October 19, 2020

**Subject: CARB's Proposed Approval of R55/B20**

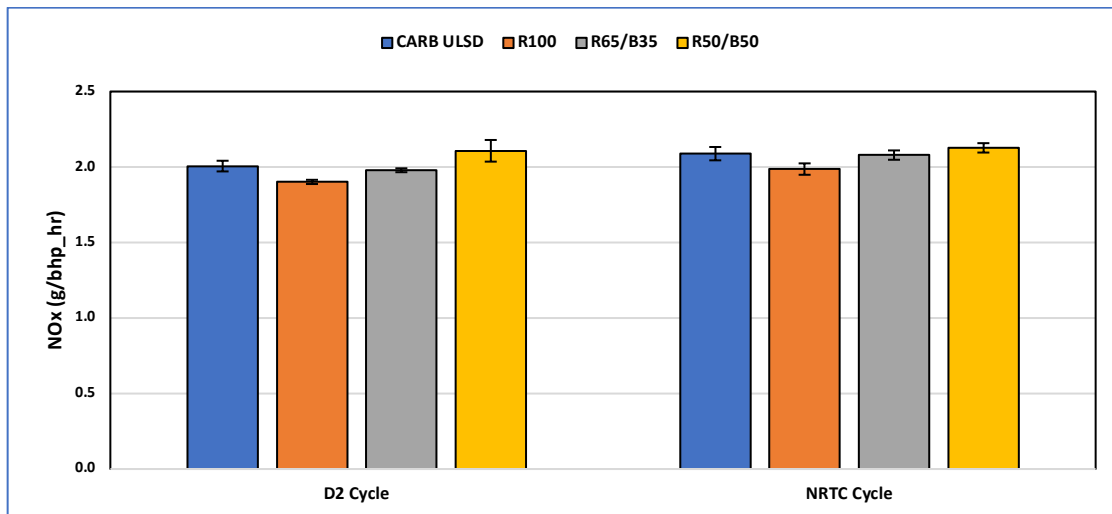
Earlier this year, CARB evaluated various renewable diesel and biodiesel blends as part of the LED program. The LED's test program legacy vehicle emissions results are provided on page 2. CARB's claim that "Staff's Supplemental Disclosure Discussion Analysis **assumed a NOx decrease of 10 percent for R100**", based on the staff report for the 2015 ADF regulation is now outdated based on the LED program's findings. CARB's 10% renewable diesel NOx reduction claim, based on the LED program emission data, is clearly inaccurate by a twofold factor. Based on the LED study's legacy vehicle emissions data, renewable diesel provides **only a 5% NOx reduction** versus a CARB ULSD. This finding alone significantly impacts CARB's past Environmental Analysis which will be addressed in a separate public comment. CARB has stated that B20 increases NOx 4%. Based on R100 reducing NOx by 5%, R55 is not capable of overcoming the 4% NOx increase from the addition of 20% biodiesel.

**Questions: Did CARB consider the LED program's emissions data when drafting the proposed approval of R55? If not, why?**
